Office Action Summary	Application No. 10/522,044	Applicant(s) DROTT ET AL.	
	Examiner Gilbert Y. Lee	Art Unit 3673

DETAILED ACTION

3. Claims 15-20 and 22-26 are rejected under 35 U.S.C. 102(b) as being anticipated by Zollner (US Patent No. 4,602,791).

For reference characters A-F refer to the Examiner's Attachment 1.

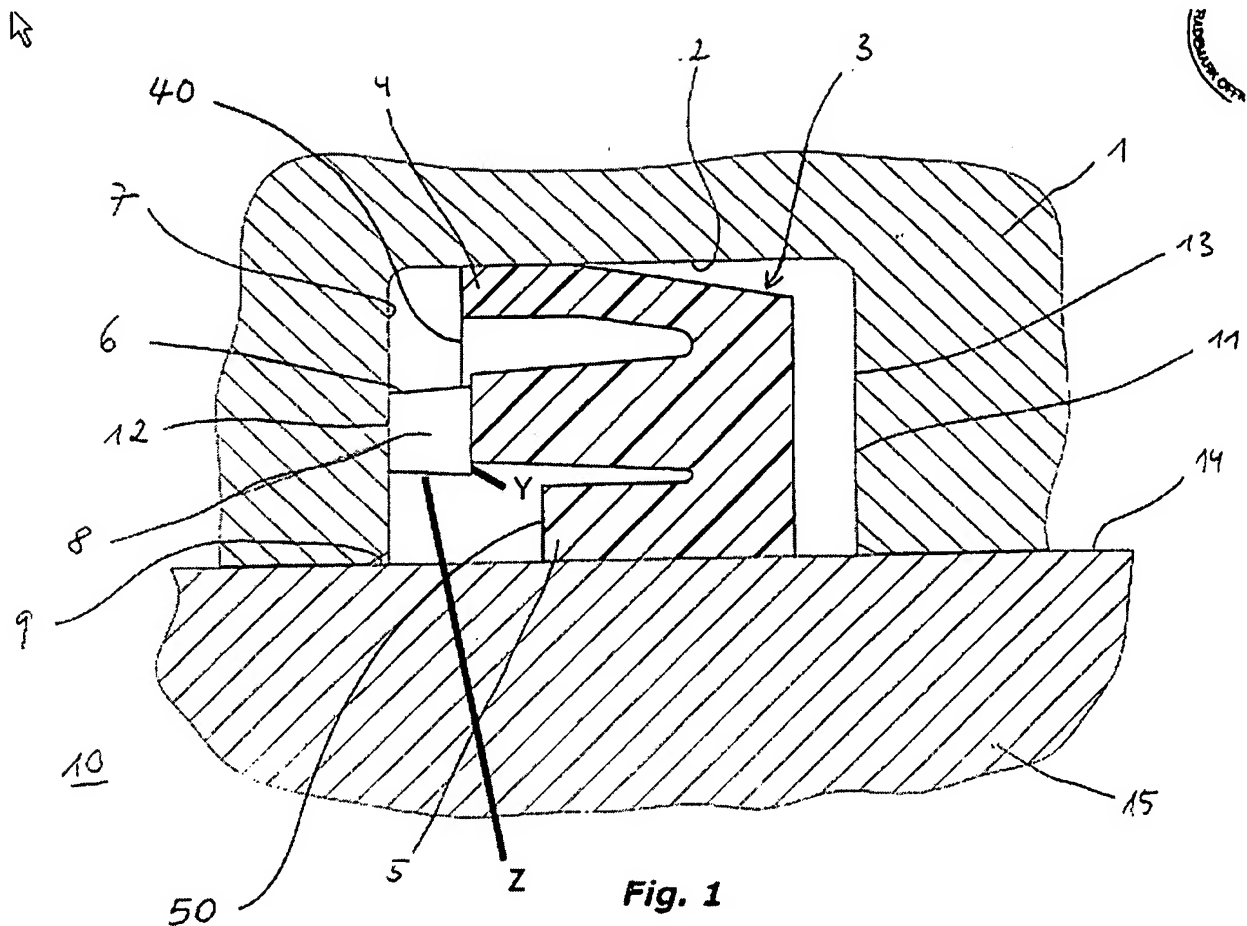
Regarding claim 15, the Zollner reference, as best understood, discloses a cylinder-and-piston unit (Col. 1, Lines 5-15) comprising a cylinder (5), a piston (6) and a sealing collar (19 or 22), the sealing collar inserted in a groove (e.g. groove of element 5 containing elements 19 and 21 or elements 21 and 22) that is recess in an interior wall surface of the cylinder and comprising an outside sealing lip (B) and an inside sealing lip (A), the outside and inside sealing lips each having a free end (i.e. the ends facing

downwards in Fig. 2), the sealing collar further including a circumferential extension (C) that extends in parallel to the sealing lips (Fig. 2), is arranged radially between the outside sealing lip and the inside sealing lip and projects axially beyond the free ends of the outside and inside sealing lips (Fig. 2), the circumferential extension being configured to contact a side wall (e.g. wall of element E in contact with element 19 or wall of element 21 in contact with element 22) in the groove (Fig. 2) and maintain the free ends of the outside and inside sealing lips out of contact with the sidewall (Fig. 2).

Regarding claim 16, the Zollner reference, as best understood, discloses a cylinder-and-piston unit (Col. 1, Lines 5-15) comprising a cylinder (5), a piston (6) and a sealing collar (19 or 22), the sealing collar received in a groove (e.g. groove of elements 5 and E containing elements 19 and 21 or groove made by elements 5, 21 and D containing element 22) that is recessed in an interior wall surface (i.e. surface of element 5 in contact with B) of the cylinder, the sealing collar comprising a first sealing lip (A) and a second sealing lip (B), the first sealing lip being acted upon dynamically and making contact with the piston (Fig. 2) and the second sealing lip thereof being acted upon statically while resting on a bottom of the groove (Fig. 2), the first and second sealing lips each having a free end (i.e. the ends facing downwards in Fig. 2), the sealing collar further including a circumferential extension (C) that extends between the first and second sealing lips (Fig. 2), and projects from the first and second sealing lips in an axial direction beyond the free ends of the first and second sealing lips (Fig. 2), the sealing collar having a rear surface (e.g. surface of elements 19 or 22 in contact with elements 21 or D respectively) opposite the free ends of the first and second

sealing lips, wherein the sealing collar has a maximum radial width at the free end of the second sealing lip and a minimum radial width at the rear surface (Fig. 2). Note that the radial width at the rear surface will always be smaller than the maximum width because of supporting ring 1.

Regarding claim 17, the Zollner reference, as best understood, discloses the axial width of the groove (e.g. groove of elements 5 and E containing elements 19 and 21 or groove made by elements 5, 21 and D containing element 22) being larger than the axial width of the sealing collar (i.e. from the rear surface of element 19 or 22 to the tip of the extension C in contact with E and 21 respectively).

Regarding claim 18, the Zollner reference, as best understood, discloses the second sealing lip (B). Note that the second lip of the Zollner reference is capable of being passed over by pressure fluid flow and hence provide the effect of a valve, because the structure as claimed in claim 16 is the same as the structure of the Zollner reference.

Regarding claim 19, the Zollner reference, as best understood, discloses the strength of the extension as a difference between its inside and outside diameters has at least the same rate as the strength of each of the sealing lips. Note that the seal of the Zollner reference is made of one material and since the extension has a thicker diameter, it will have a strength that is equal, if not greater, than the strength of the lips.

Regarding claim 20, the Zollner reference, as best understood, discloses the extension being provided with radial apertures (F). Note that the apertures are capable of allowing pressure fluid to pass through in a radial direction.

Regarding claim 22, the Zollner reference, as best understood, discloses the apertures being open in an axial direction towards the free end of the extension (Fig. 2).

Regarding claim 23, the Zollner reference, as best understood, discloses the extension being integrally connected to the sealing collar and being made of the same material (Fig. 2).

Regarding claim 24, the Zollner reference, as best understood, discloses a cylinder-and-piston unit (Col. 1, Lines 5-15) comprising a cylinder (5), a piston (6) and a sealing collar (19 or 22), the sealing collar received in a groove (e.g. groove of element 5 containing elements 19 and 21 or elements 21 and 22) that is recessed in an interior wall surface (i.e. surface of element 5 in contact with B) of the cylinder, the sealing collar comprising an outside sealing lip (B) and an inside sealing lip (A), the outside and inside sealing lips each having a free end (i.e. the ends facing downwards in Fig. 2), the sealing collar further including a circumferential extension (C) that extends in parallel to the sealing lips (Fig. 2), is arranged radially between the outside sealing lip and the inside sealing lip and has a free end that projects axially beyond the free ends of the outside and inside sealing lips (Fig. 2), the circumferential extension engaging a side wall (e.g. wall of element E in contact with element 19 or wall of element 21 in contact with element 22) in the groove (Fig. 2) and maintaining the free ends of the outside and inside sealing lips out of contact with the sidewall (Fig. 2).

Regarding claim 25, the Zollner reference, as best understood, discloses the free end of the circumferential extension being provided with radial apertures (F). Note that

the apertures are **capable of** allowing pressure fluid to pass through in a radial direction.

Regarding claim 26, the Zollner reference, as best understood, discloses the sealing collar having a rear surface (e.g. surface of element 19 or 22 in contact with element 1 that is parallel to the surface of element C in contact with element E or 21 respectively) opposite the free ends of the outside and inside sealing lips, wherein the sealing collar has a maximum outside diameter at the free end of the outside sealing lip and a minimum outside diameter at the rear surface (Fig. 2). Note the minimum outside diameter is the same width as the supporting ring 1 and will always be smaller than the maximum diameter at the outside seal.

6. With regards to the applicant's argument of the groove of the Zollner reference, the argument is not persuasive because, as clearly stated in the prior office action, the cylinder is being considered as element 5. The definition of a "groove" being used, as stated in the Webster's II New Riverside Dictionary, is : a long, narrow furrow or channel. Element 22 clearly sits in a groove/recess of element 5. Clearly there are grooves on either side of element 23.
